SHOP DRAWING TRANSMITTAL

FIU PEDESTRIAN BRIDGE 434688-1-58-01
PT DECK, CANOPY AND TRUSS SHOP DRAWING
SUMMARY OF REVIEW COMMENTS BY CEG 6/26/2017 from FDOT D6

REFERENCE: UniversityCity Prosperity Project
Project ID BT-904
Submittal #000462-1.B, Post Tensioning – Deck, Canopy, Truss
(Revised)
FIGG Project No. 2262.06

Post Tensioning (Deck, Canopy & Truss)

| SHEET: | PT01.2 |

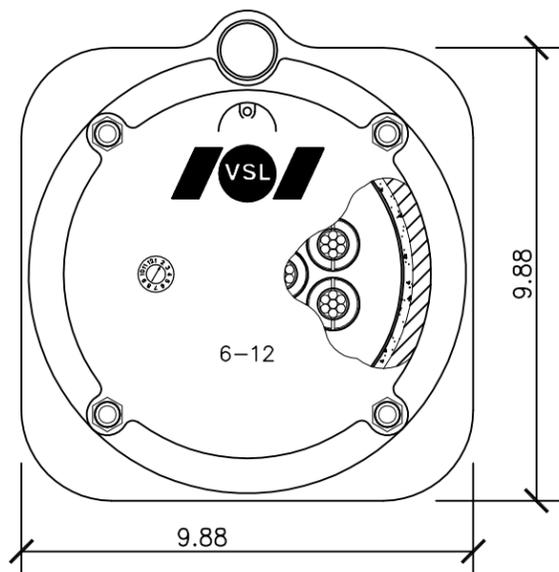
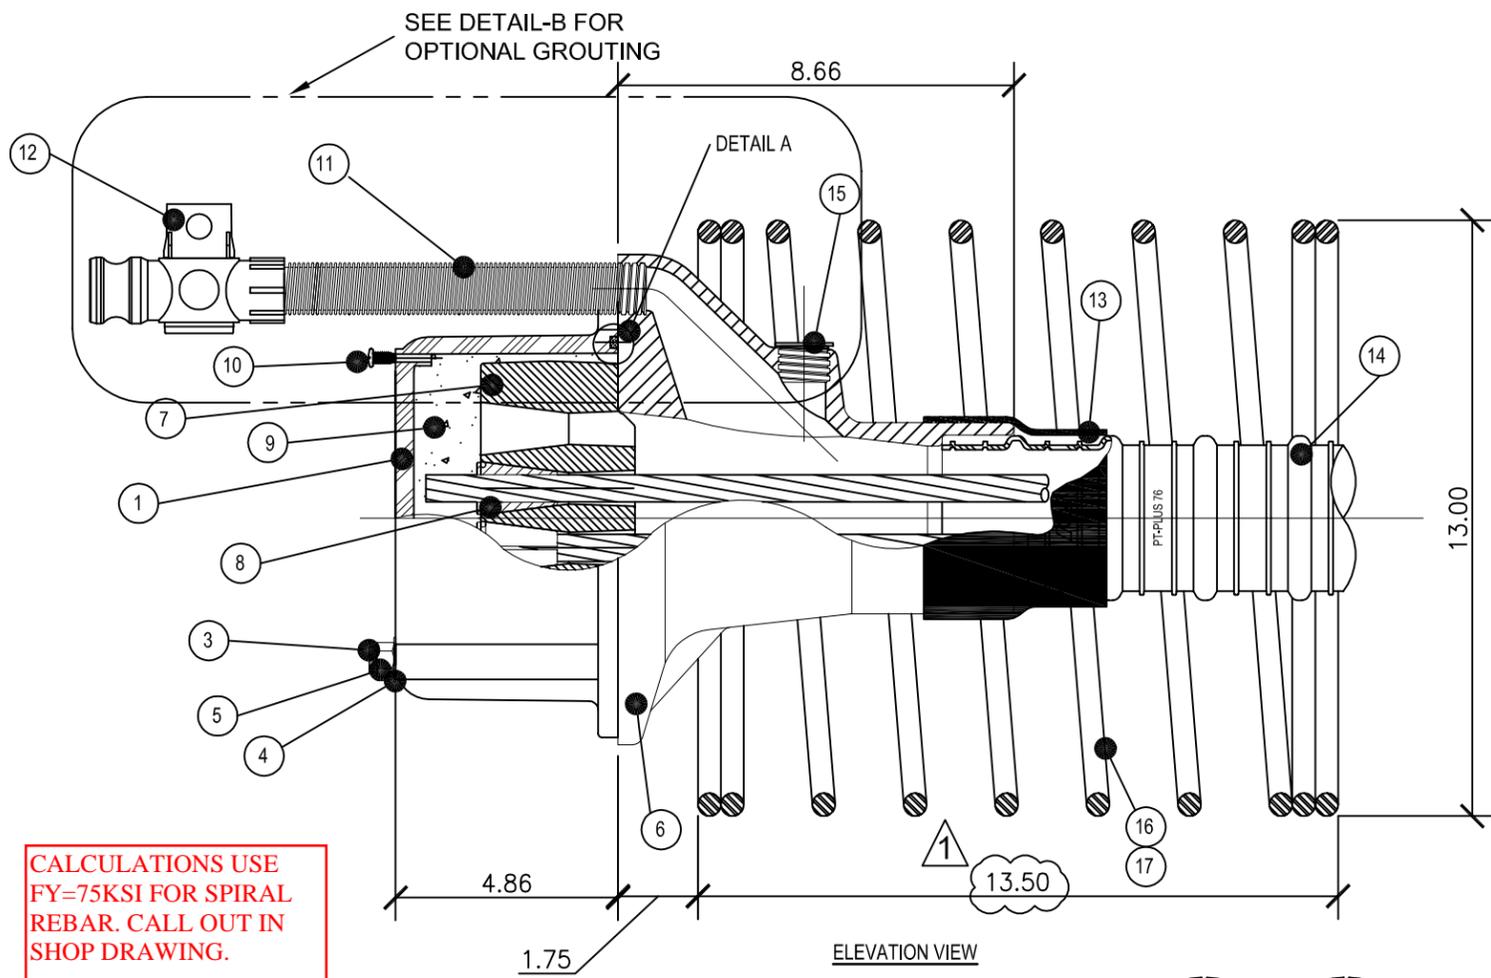
| <u>SHEET ID</u> | <u>COMMENT</u> |
|-----------------|--|
| PT01.2 | CALL OUT MATERIAL/ STEEL GRADE FOR LOCAL ZONE REINFORCEMENT IN TABLE. |
| PT01.2 & 01.4 | LOCAL ZONE REINFORCEMENT HAS A 2" PITCH. THIS IS A VERY TIGHT SPACING. WILL ANY CONFLICTS BE PRESENT WITH MILD REINFORCEMENT IN THESE AREAS? |

LOCAL ZONE REINFORCEMENT HAS A 2" PITCH. THIS IS A VERY TIGHT SPACING. WILL ANY CONFLICTS BE PRESENT WITH MILD REINFORCEMENT IN THESE AREAS?

CALL OUT MATERIAL / STEEL GRADE FOR LOCAL ZONE REINFORCEMENT IN TABLE

Please provide calculations for local zone reinforcement.

SCALE: NTS
 JOB NO: 420582
 SHEET: PT01.3

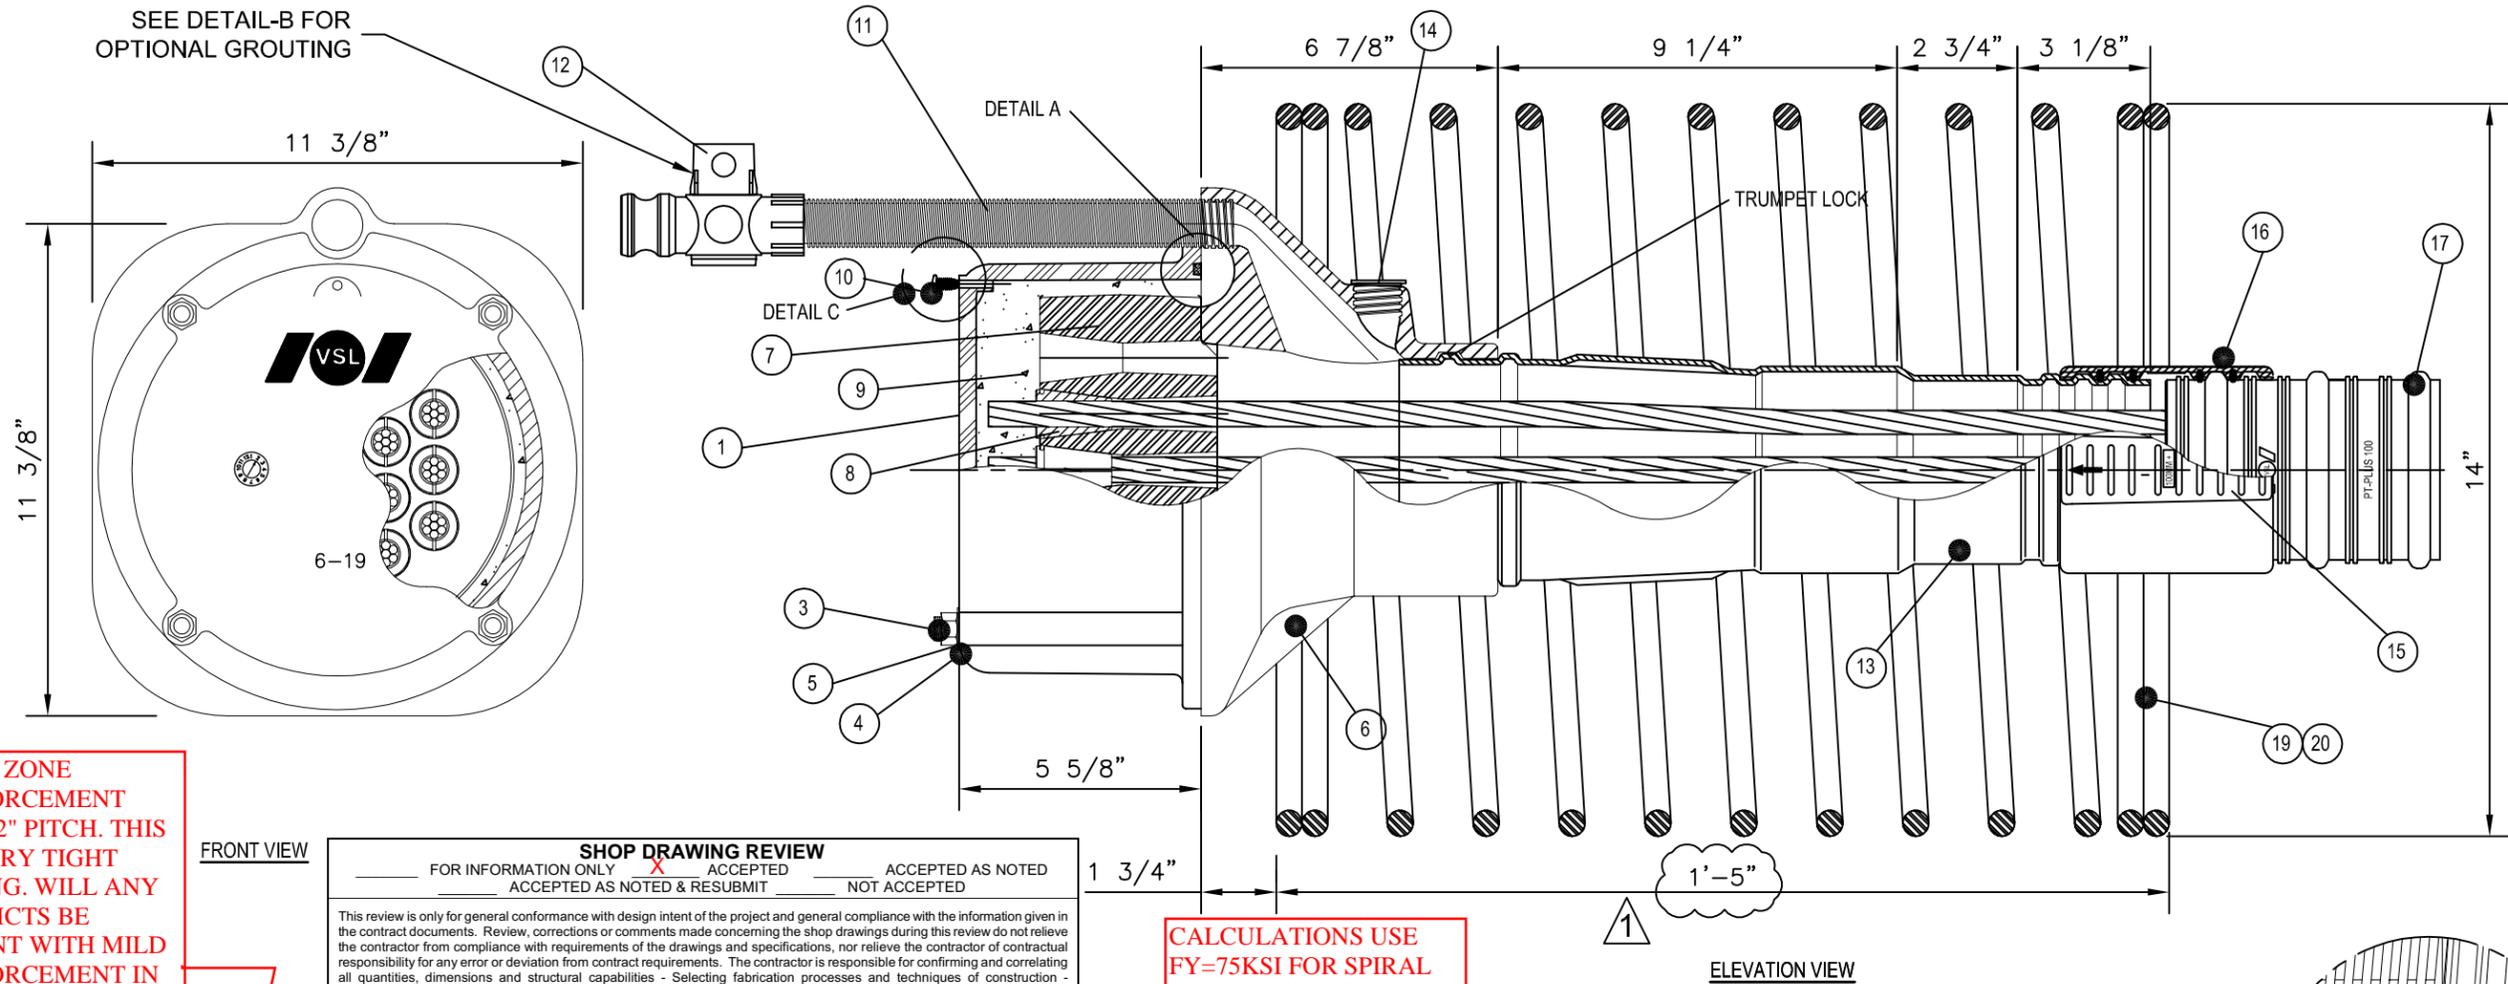
| <u>SHEET ID</u> | <u>COMMENT</u> |
|-----------------|--|
| PT01.3 & 01.4 | CALCULATIONS FOR SPIRAL USE GRADE 75 REBAR. CALL OUT FY=75KSI ON SHOP DRAWING. |

CALCULATIONS USE
FY=75KSI FOR SPIRAL
REBAR. CALL OUT IN
SHOP DRAWING.

SCALE: NTS
 JOB NO: 420582
 SHEET: PT01.4

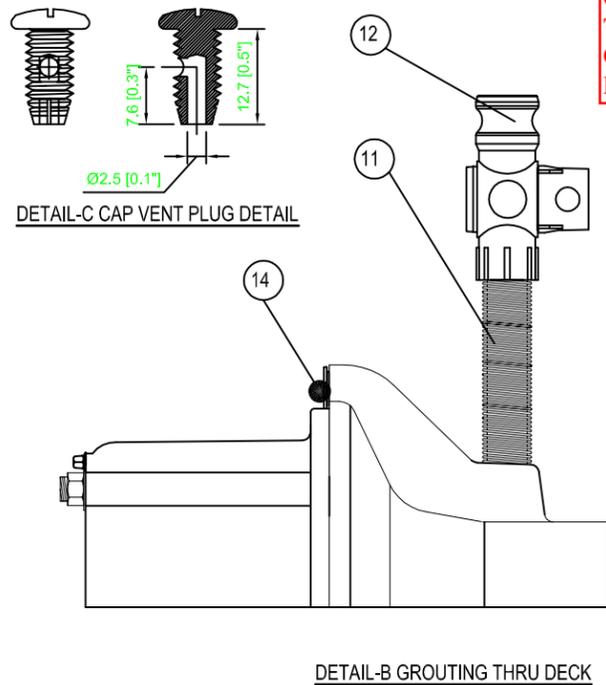
| <u>SHEET ID</u> | <u>COMMENT</u> |
|-----------------|--|
| PT01.4 | THE LOCAL ZONE REINFORCEMENT CALCULATIONS PROVIDED ARE FOR THE 15" DIA SPIRAL. SHOW CALCULATIONS FOR THE 14" DIAMETER SPIRAL AS WELL. |

CALCULATIONS USE $F_y=75\text{KSI}$ FOR SPIRAL REBAR. CALL OUT IN SHOP DRAWING.

SCALE: NTS
 JOB NO: 420582
 SHEET: PT01.5

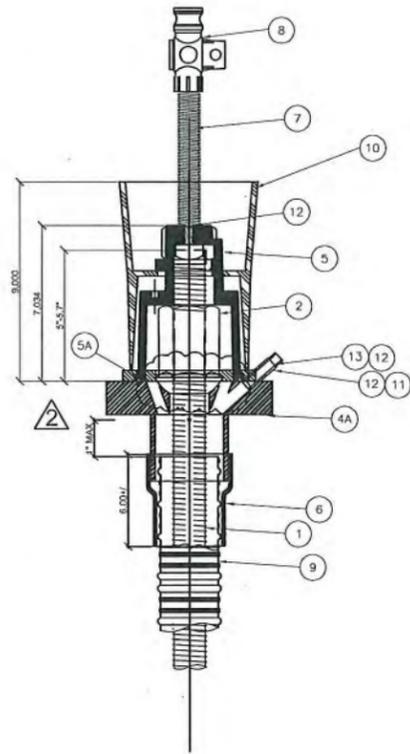
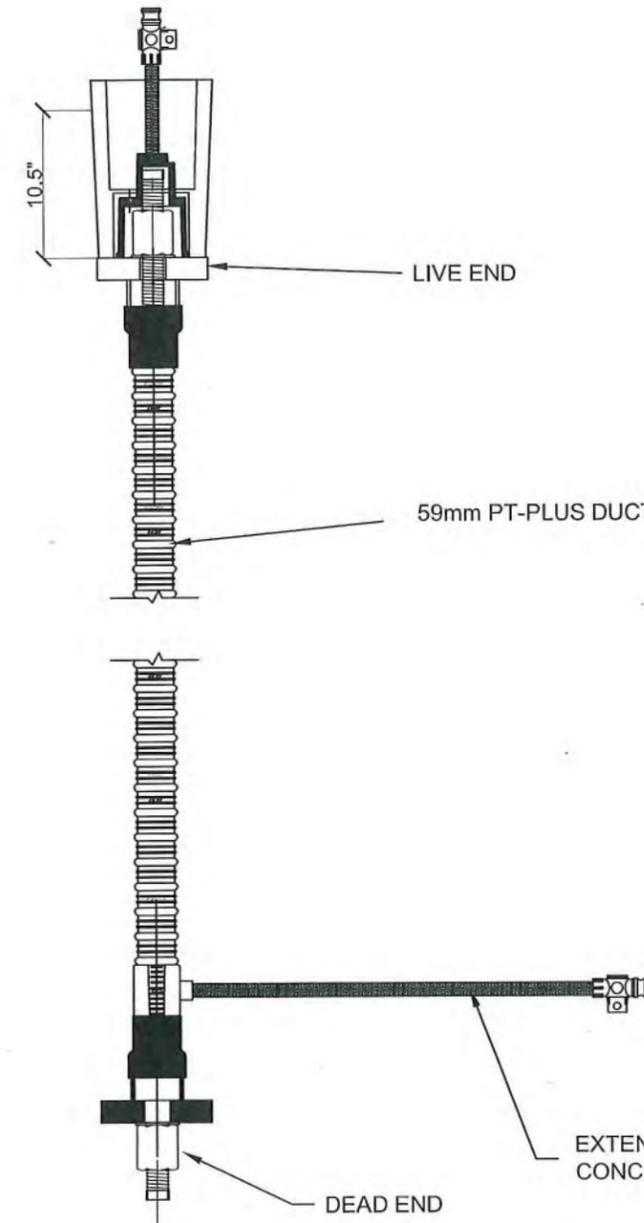
| <u>SHEET ID</u> | <u>COMMENT</u> |
|-----------------|--|
| PT01.5 | PER SHEET B-38 & 42, STEEL ANCHOR PLATE FOR 1.375" PT BAR IS 5" X 10". VERIFY W/ EOR. |

PER SHEET B-38 & 42, STEEL ANCHOR PLATE FOR 1.375" PT BAR IS 5" X 10". VERIFY W/ EOR.

| SHEET: | PT01.6 |

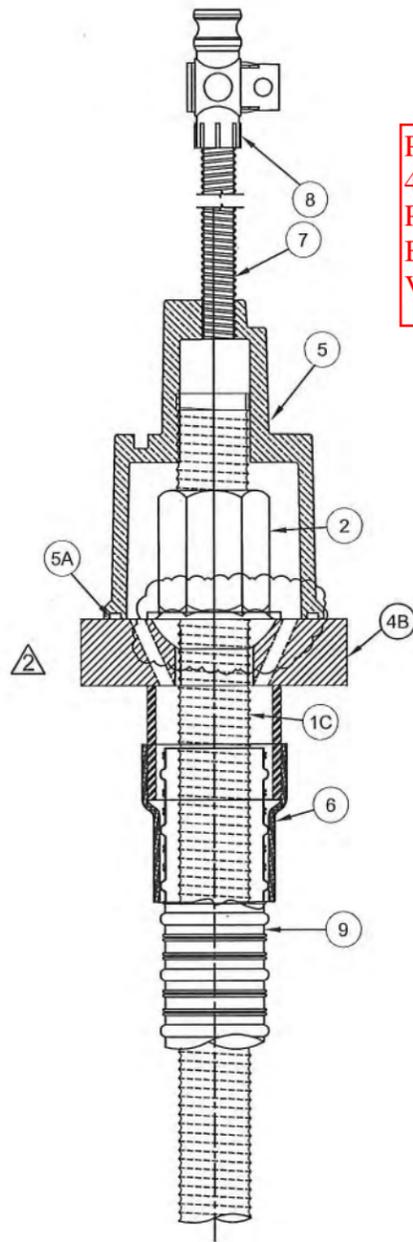
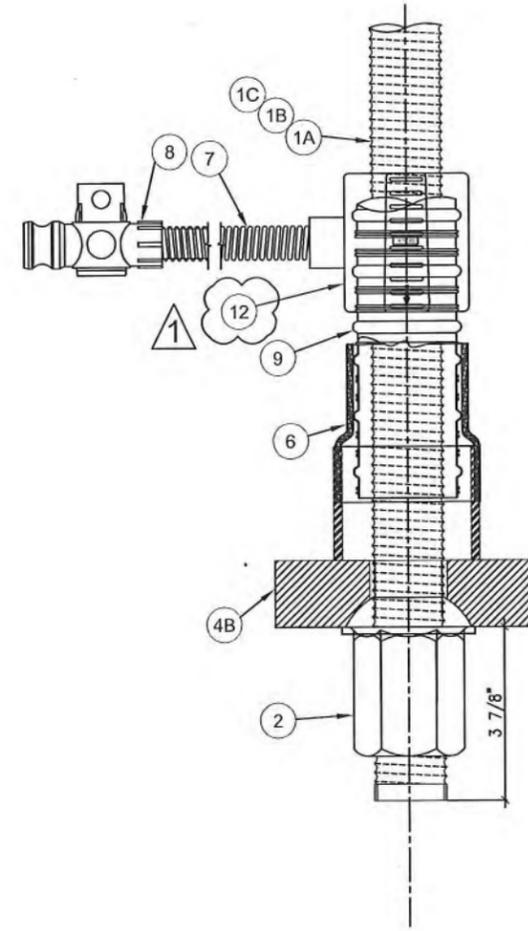
| <u>SHEET ID</u> | <u>COMMENT</u> |
|-----------------|--|
| PT01.6 | PER SHEET B-38 & 42, STEEL ANCHOR PLATE FOR 1.75" PT BAR IS 8" X 12". VERIFY W/ EOR. |

PER SHEET B-38 & 42, STEEL ANCHOR PLATE FOR 1.375" PT BAR IS 8" X 12". VERIFY W/ EOR.

| SHEET: | PT01.7 |

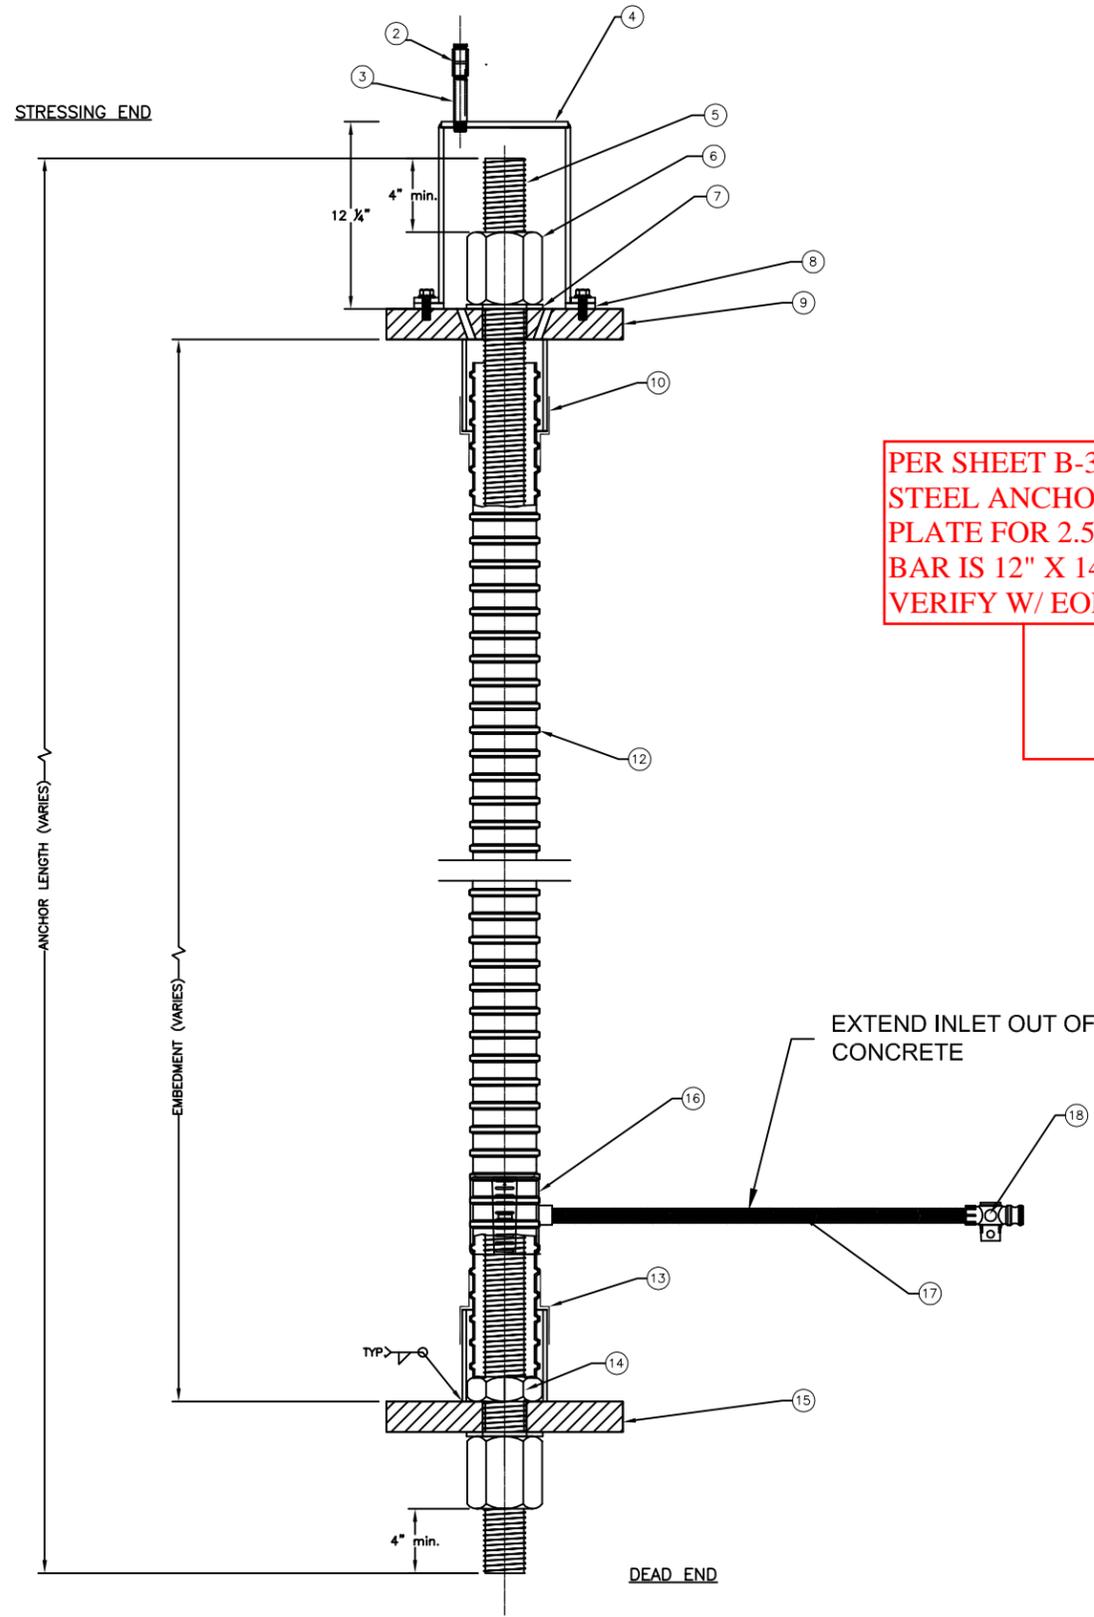
| <u>SHEET ID</u> | <u>COMMENT</u> |
|-----------------|--|
| PT01.7 | PER SHEET B-38, STEEL ANCHOR PLATE FOR 2.5" PT BAR IS 12" X 14". VERIFY W/ EOR. |

PER SHEET B-38,
STEEL ANCHOR
PLATE FOR 2.5" PT
BAR IS 12" X 14".
VERIFY W/ EOR.
